Bulletin 01/2013

Subject: Caterpillar MD6420 Mast Pivot Connection Bolts
May be Incorrect Grade

Affected Product: Caterpillar MD6420 (SK75i, SKS, SKS-W) Drills.

Figure 2 Bolt location

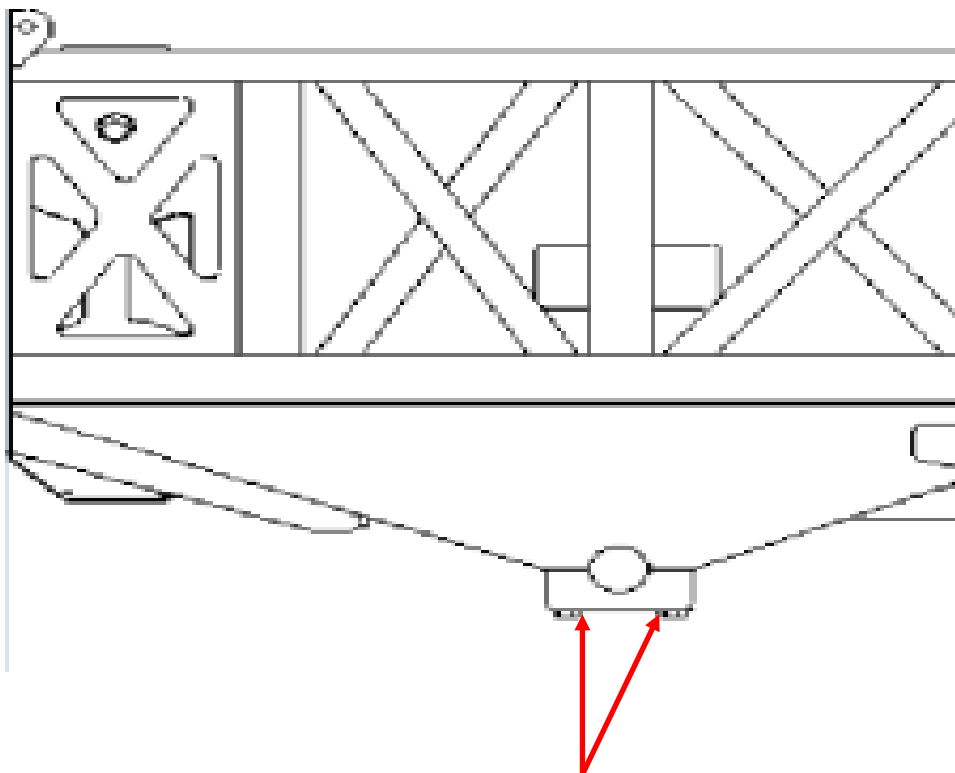
Inspect the mast pivot connection area to ensure that Grade 8 bolts have been installed at all positions. (Ref: Figures 1, 2 & 3 Below)

Do Not Operate the Machine if this connection has Grade 5 bolts or if the findings reveal a mix of Grade 5 and Grade 8 bolts in the mast pivot connection joint.

Machines should be tagged 'out of service' in accordance with site procedures and not be returned to service until all incorrect bolts have been replaced with the correct part and torqued to specification
